The Nexus- Tower 2- L19- Revised office toilet- Instruction

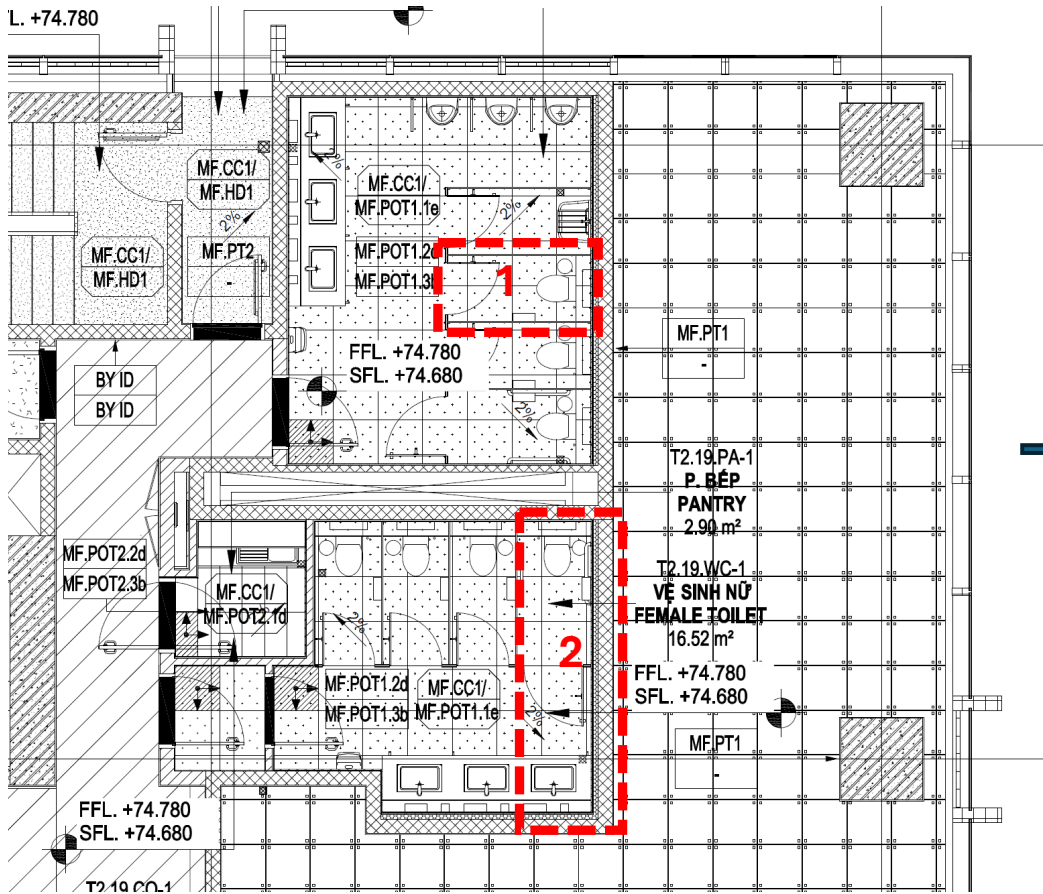
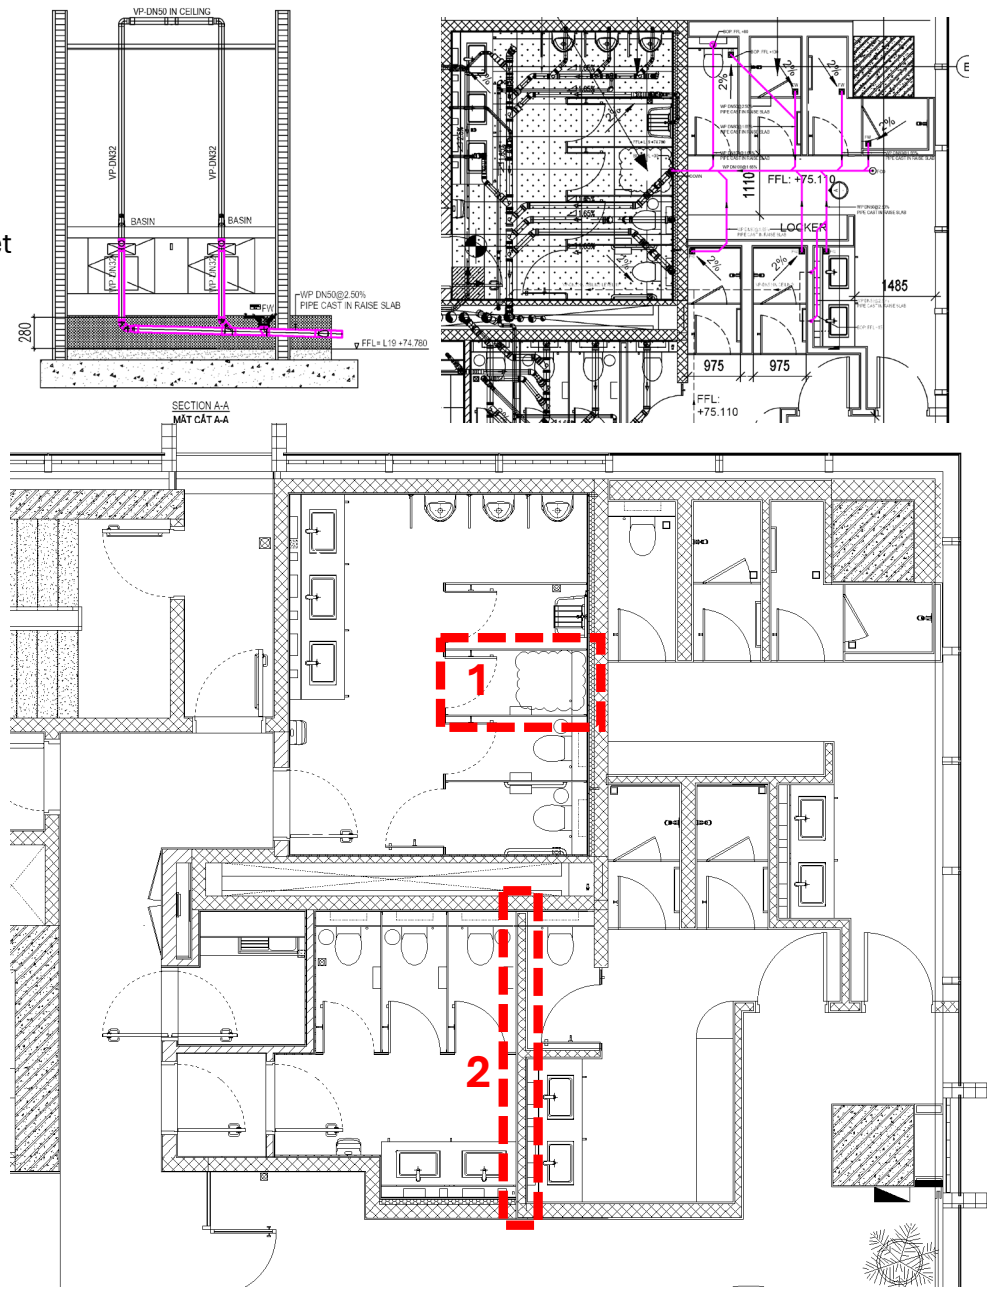
- 1. Provide drainage connection for Gym toilet by utilizing 1 toilet in Male room
- 2.1 Dismantle and handover sanitary appliance and equipment at impacted area
- 2.2 Demolish existing wall and build new wall dividing Office toilet and Gym toilet
- 2.3 Water proofing, protecting and making good the impacted wall, ceiling and floor at office female toilet
- 2.4 Adjust Female vanity counter and toilet cubical
